CAMDEN COUNTY PLANNING BOARD
CHARLES J. DEPALMA COMPLEX
2311 EGG HARBOR ROAD
LINDENWOLD, NJ 08021

February 22, 2022

**CAMDEN COUNTY PLANNING BOARD
COUNTY ENGINEER'S REVIEW
OF SUBDIVISIONS AND
SITE DEVELOPMENT PLANS**

**COUNTY PLAN:
SP-12-9-21**

STAFF REPORT MEETING OF:	RE:	PSE&G Echelon Substation
	Plan:	SP-12-9-21
	Municipality:	Cherry Hill
	Applicant:	PSE&G
	Abuts County Route:	Evesham Rd. Cr. 544

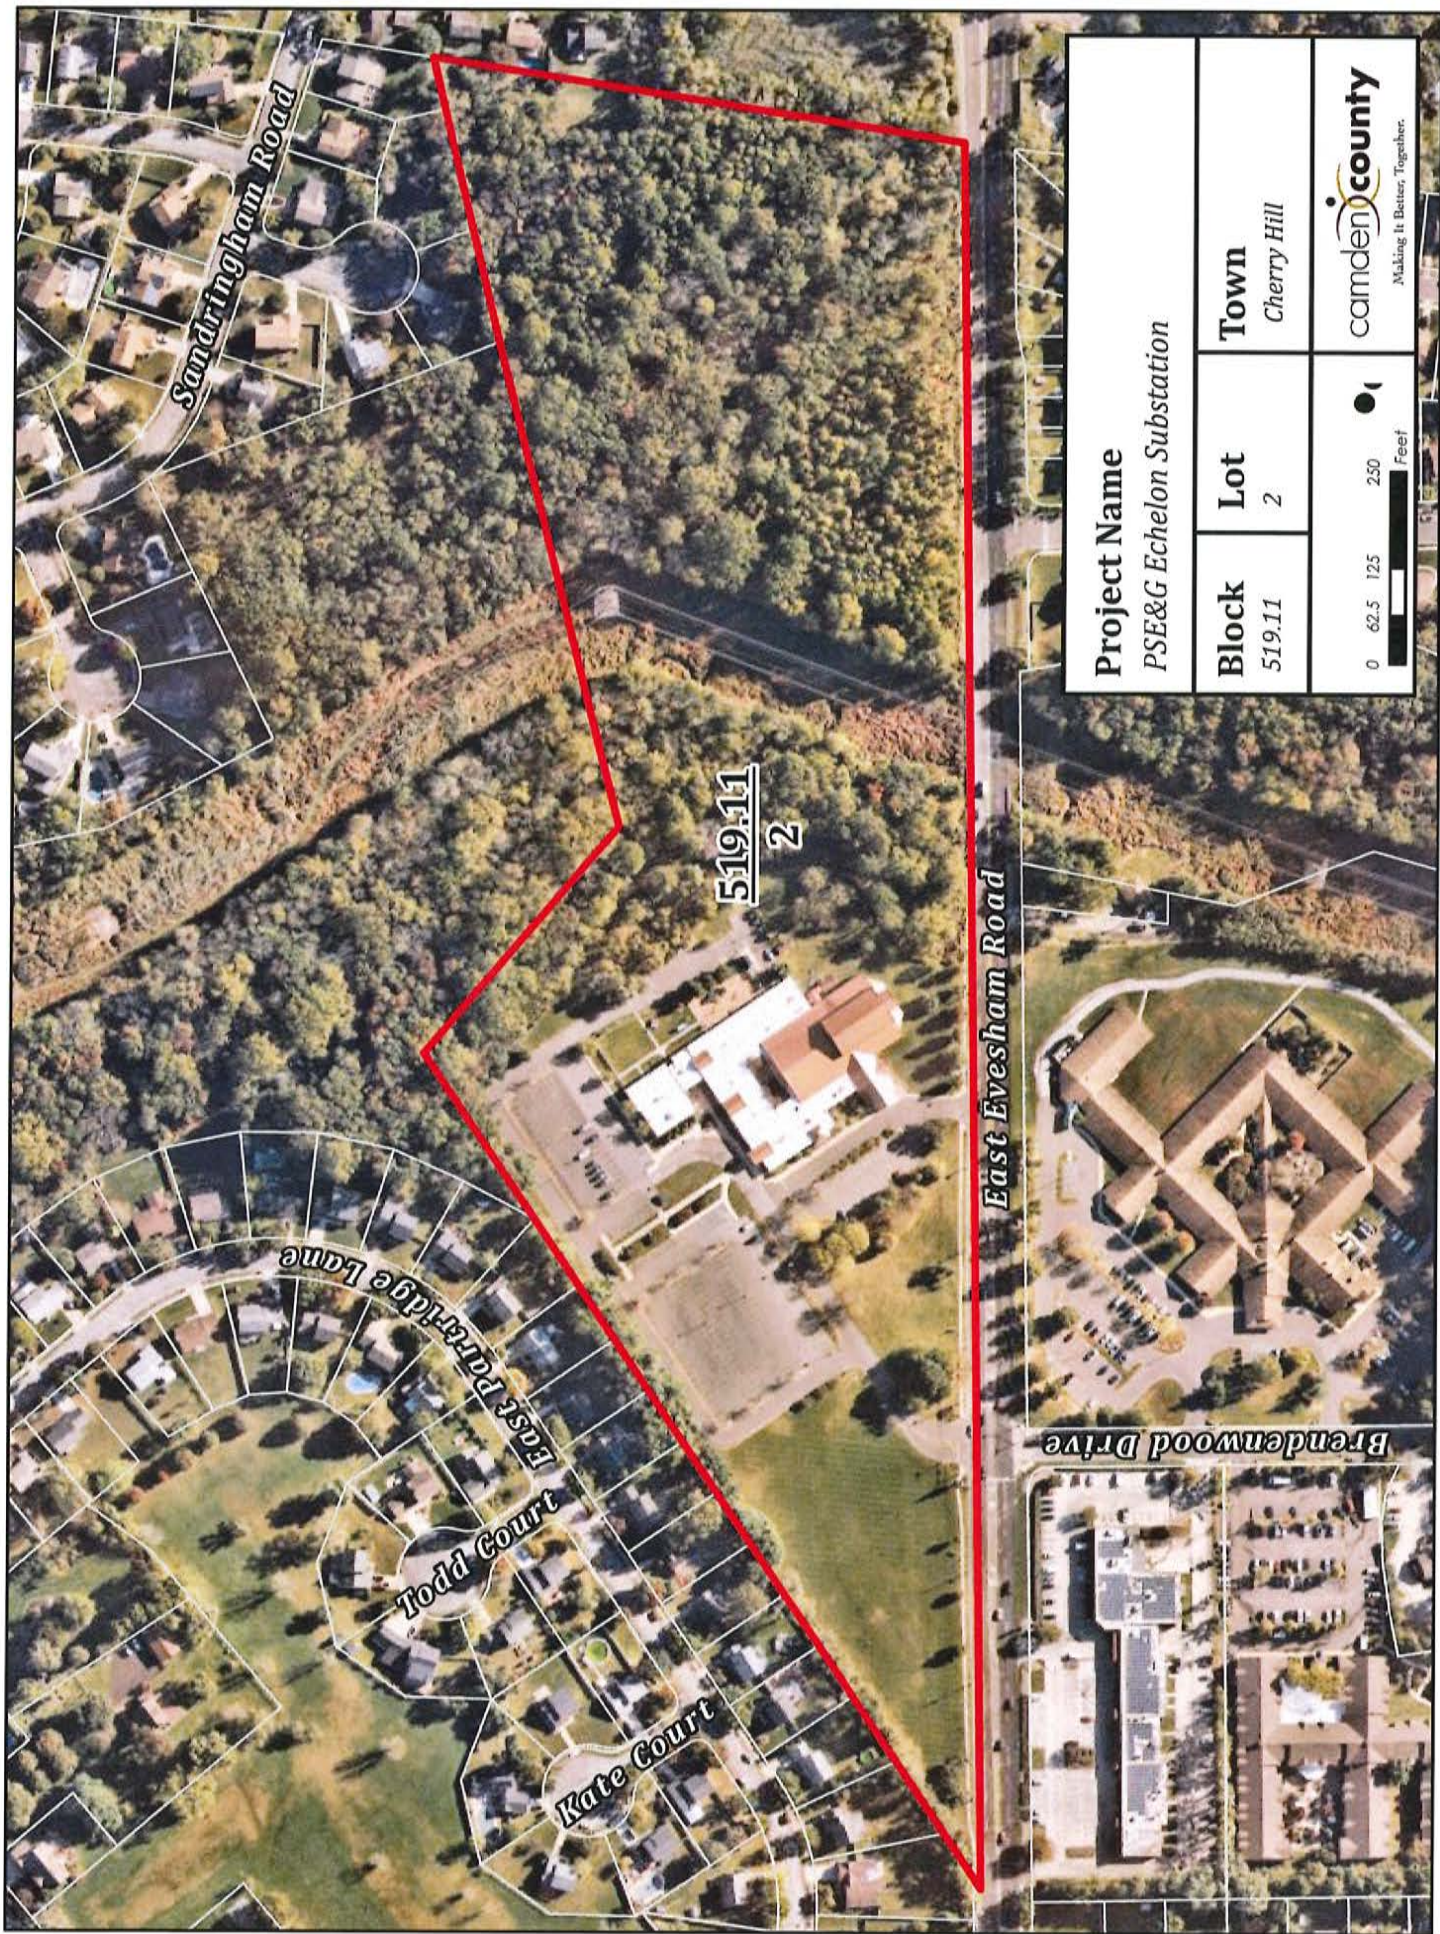
The Applicant is seeking approval to subdivide an 11-acre portion of Block 519.11 Lot 2 to construct a new unoccupied substation and expand their current network in Cherry Hill Township. Specific construction includes a control house, lighting mast monopoles, an A – Frame and security fencing.

The applicant proposed to construct guiderail within the County Right of Way.

STAFF REPORT MEETING OF:	RE:	Voorhees Storage, LLC
	Plan:	SP-34-3-21
	Municipality:	Voorhees
	Applicant:	Voorhees Storage, LLC
	Abuts County Route:	Cooper Rd. Cr. 675 and Kresson-Gibbsboro Rd. Cr.685

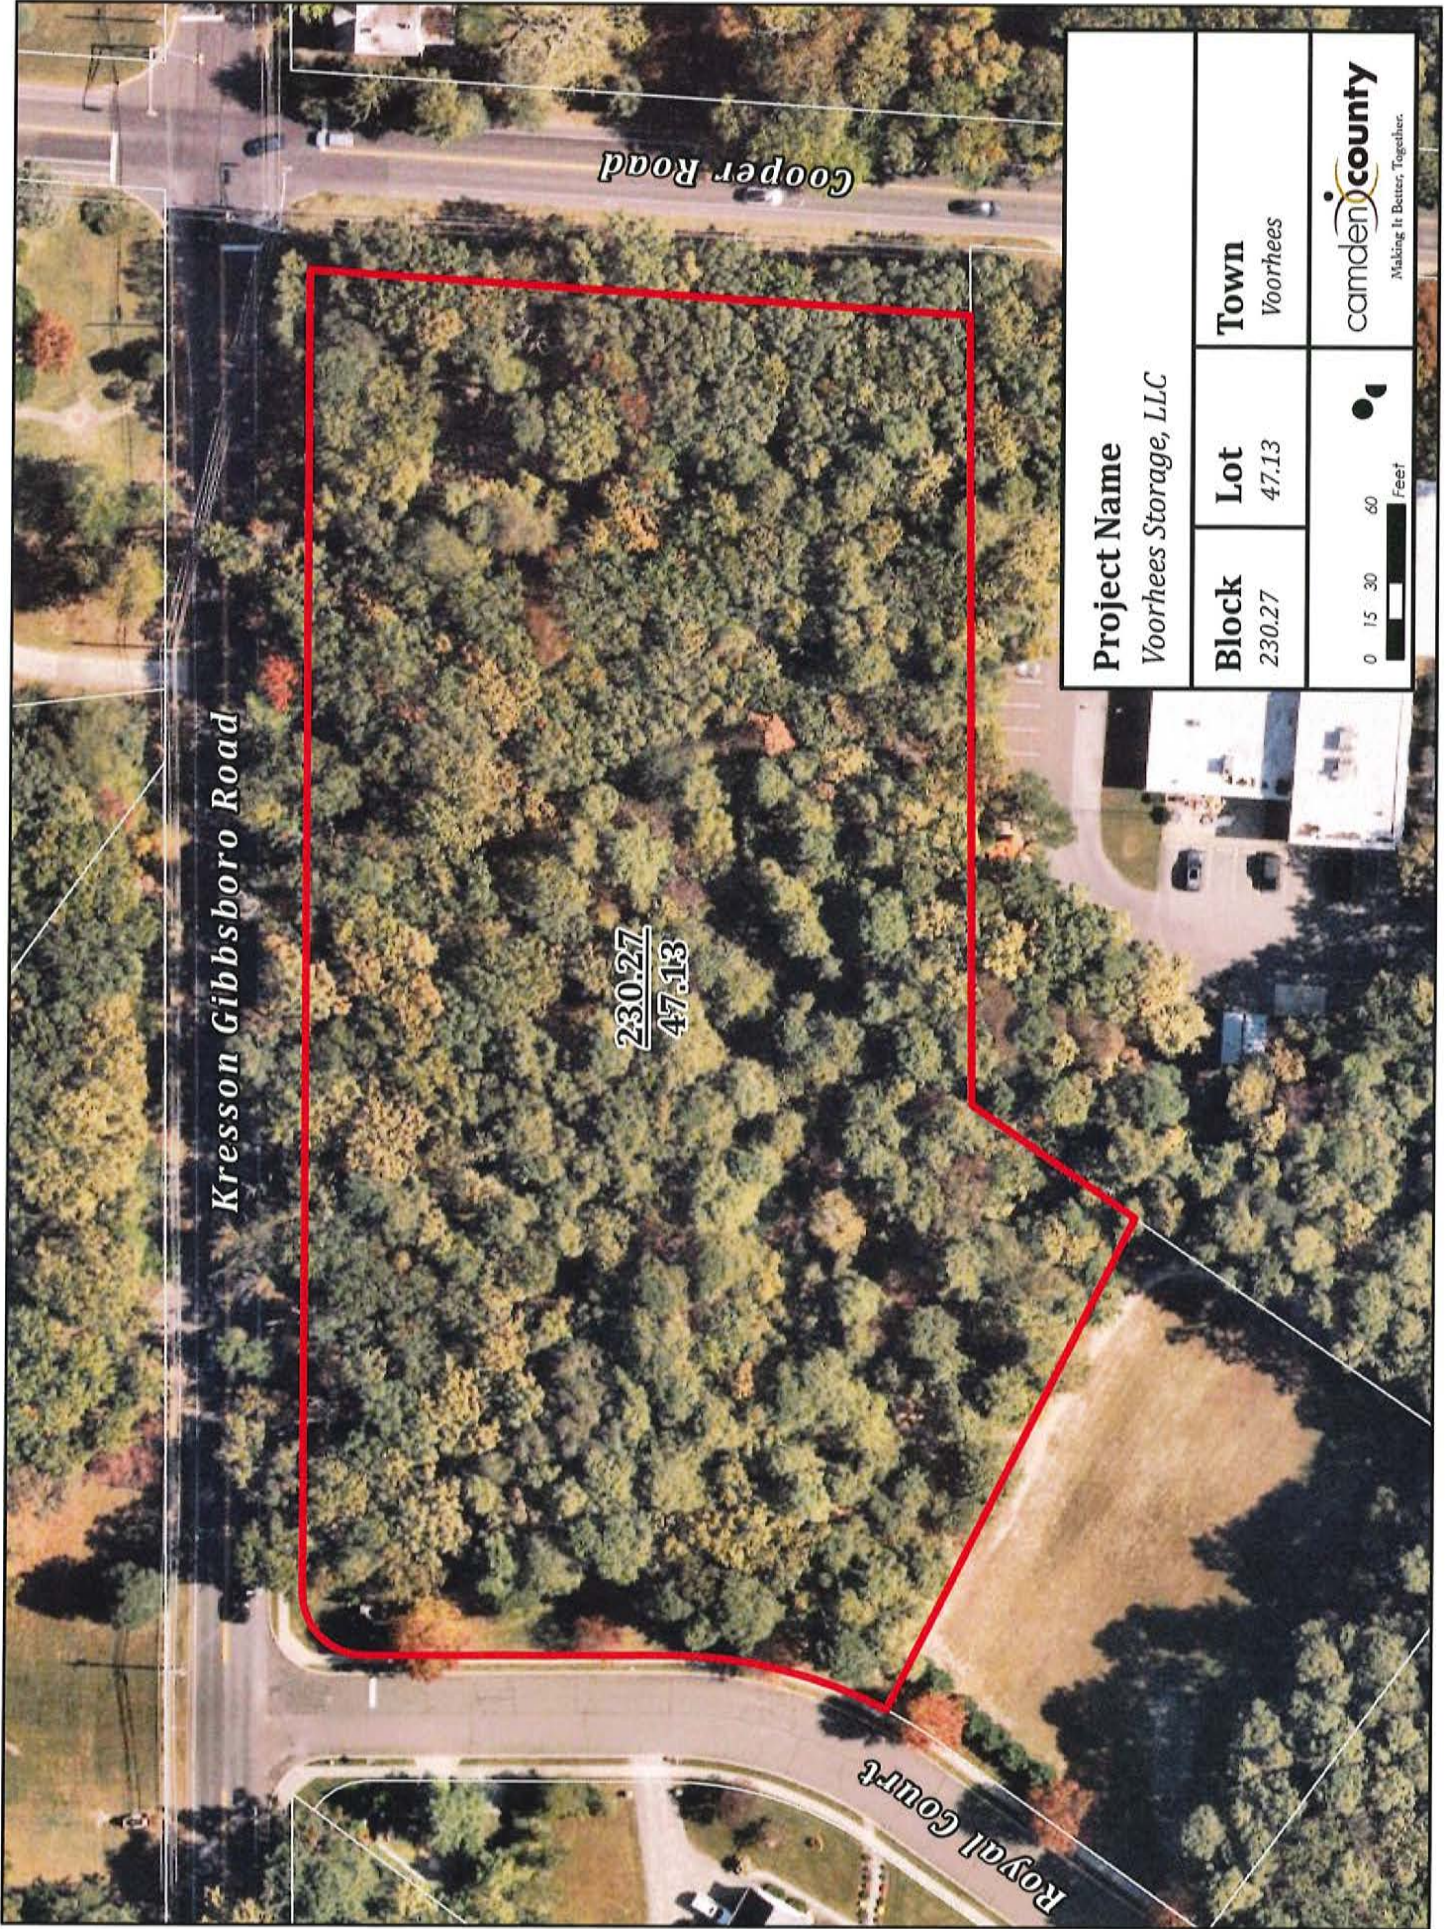
County Planning Board staff has discussed the need for two full access driveways with the applicant and recommends one full access driveway only. The full access driveway proposed on Cooper Rd. Cr. 675 will remain and the proposed driveway on Kresson- Gibbsboro Rd. Cr. 685 will be eliminated. The applicant has expressed the need for emergency access to the site. County staff recommends that an emergency access drive be located on Kresson-Gibbsboro Rd. at a point furthest away from the centerline of the signalized intersection with Cooper Rd. and be accessible by emergency vehicles only using a breakaway chain or lock box to gate the driveway.

STAFF REPORT MEETING OF:	RE:	308 Haddonfield Rd.
	Plan:	SP-34-1-22
	Municipality:	Voorhees
	Applicant:	Alfred Furia
	Abuts County Route:	Haddonfield Rd. Cr. 561

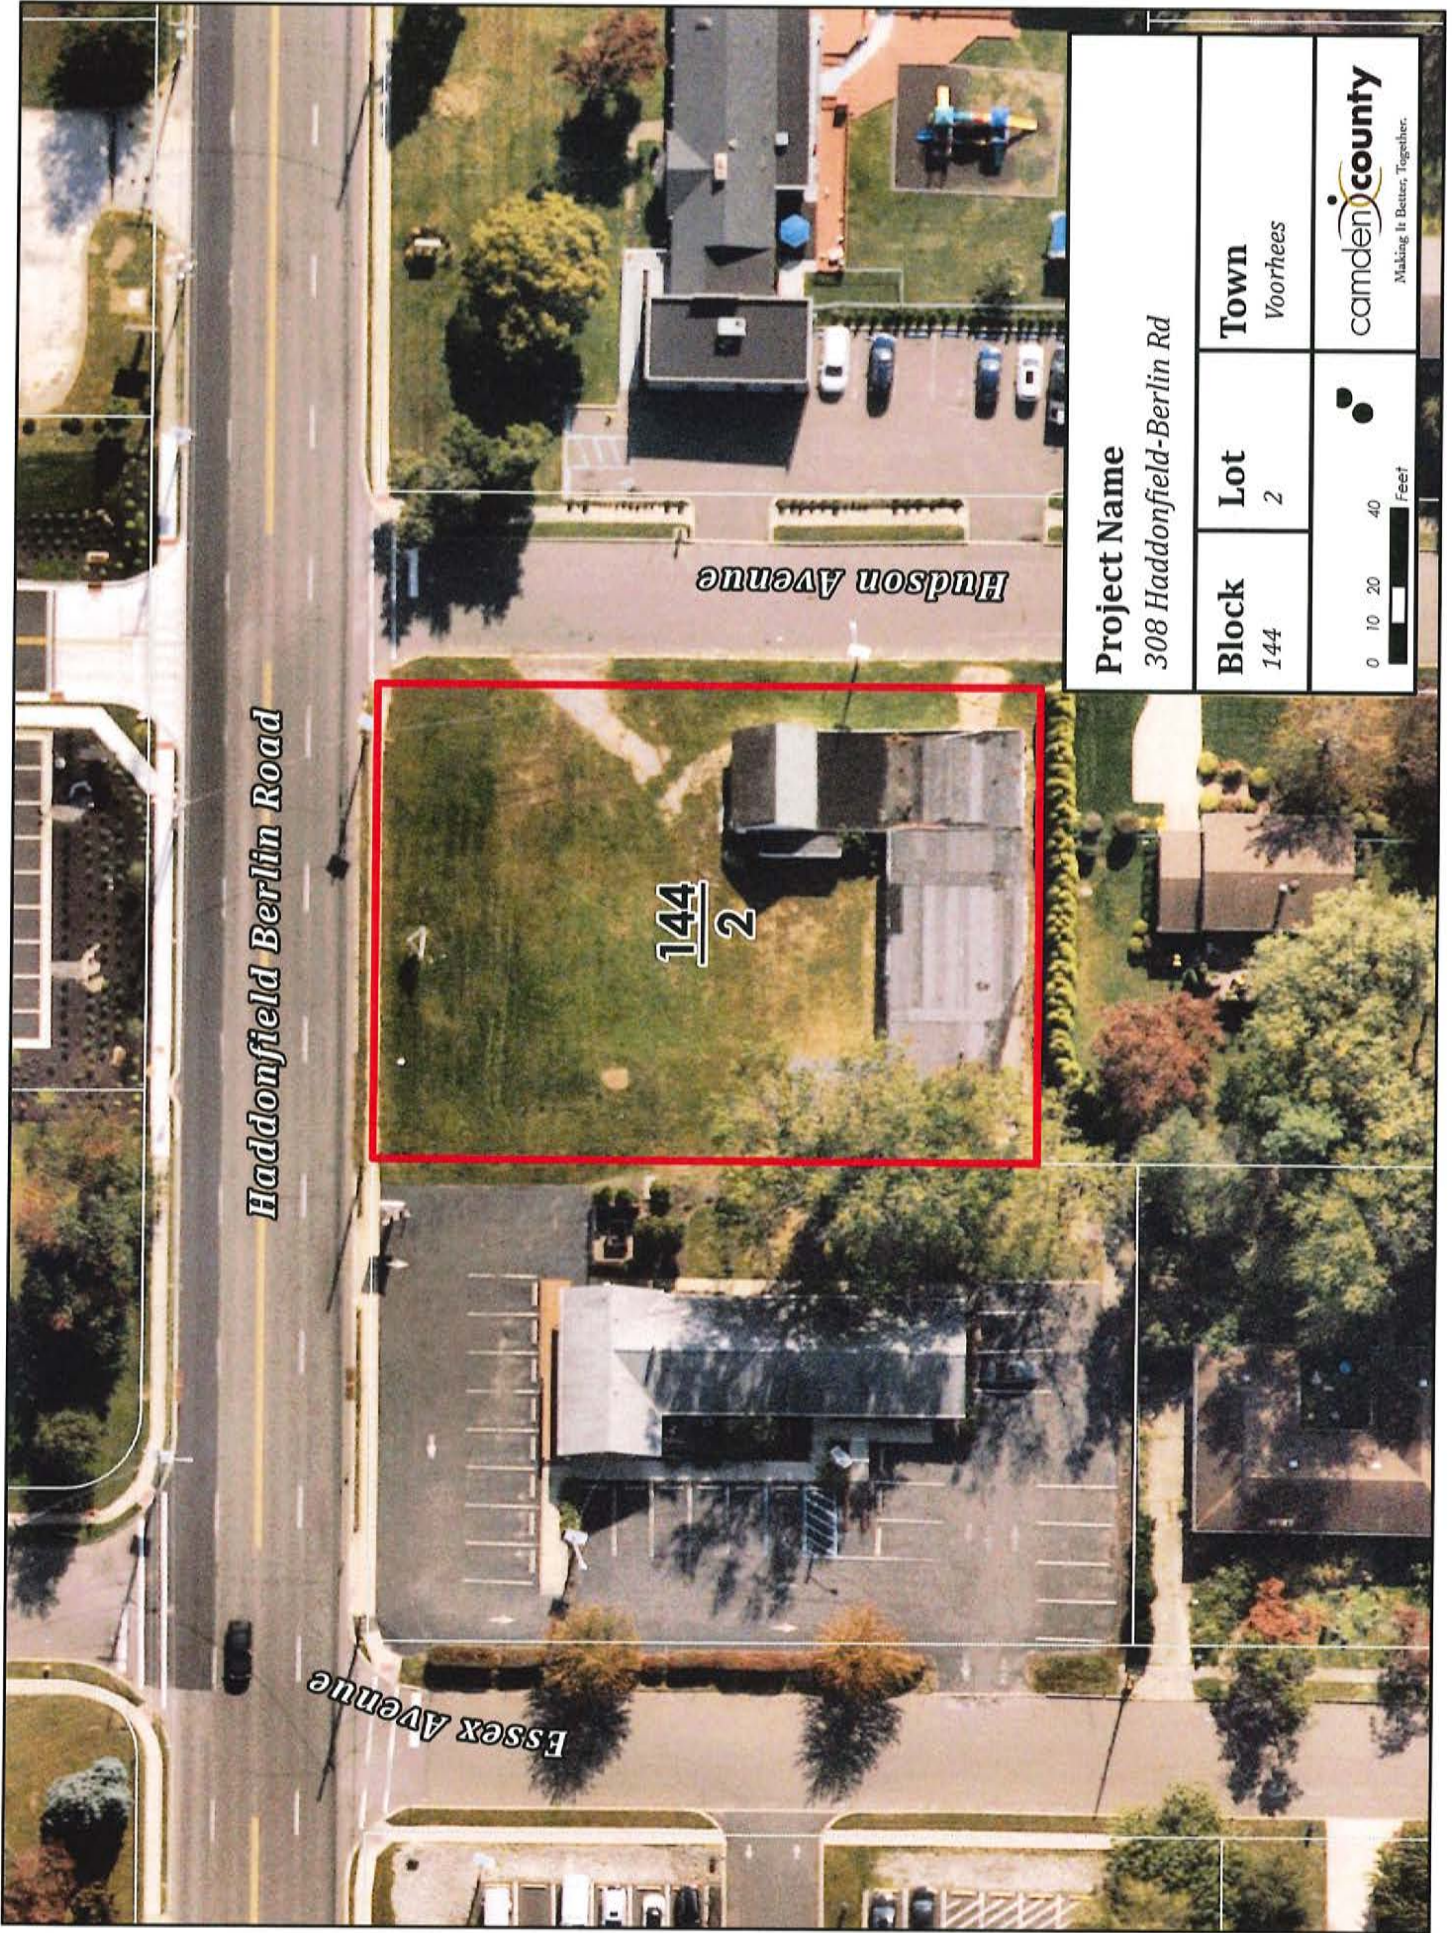
The Applicant is proposing to partially demolition the existing building an renovate the remainder into an Italian Deli with prepared foods. The property resides on the corner of Haddonfield Berlin Rd. Cr. 561 and Hudson Ave. (local street). The existing condition is that the property has two full access driveways one on Haddonfield Berlin Rd. Cr 561 and one on Hudson Ave. The development proposal is to limit the driveway on Cr. 561 to one-way ingress only, allowing left turns into the site. Egress will be from a full access driveway on Hudson Ave. which is a public street that connects to Cr. 561. Driveway modifications in the County right of way along CR 561 include a new driveway apron and depressed curb and curb returns, striped crosswalk, handicapped ramps and curb returns.
